Includes: Sound Attenuators for AHU
Job Name: Webster Science Bldg.
Contractor: ICON Mechanical
TMI Ref #:

Shop Drawing Submittal Review

Project Name: Webster University-**ISB**

Copies	No.	Description
1 PDF	238800M04	(Submittal No.'s) (R&B CxSRC)
		(Cannon #238800-007) - (Paric #15051-0199) - (WES #607)
		• Sound Attenuator

Dwg #: **117840-1**

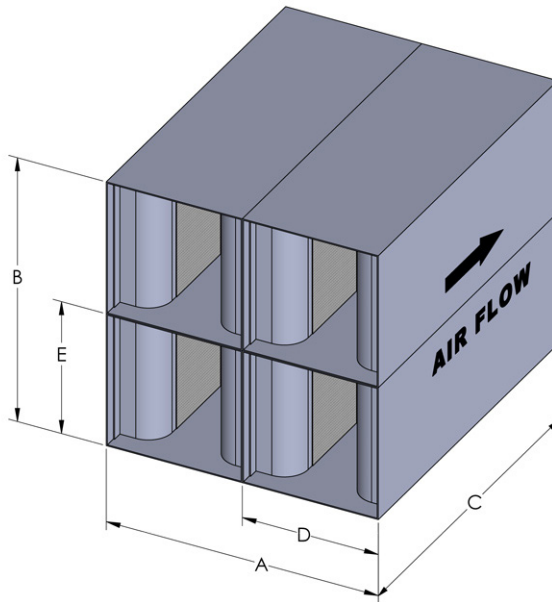
Provide erosion barrier/media protection as specified in section 238800 and as required to protect media.
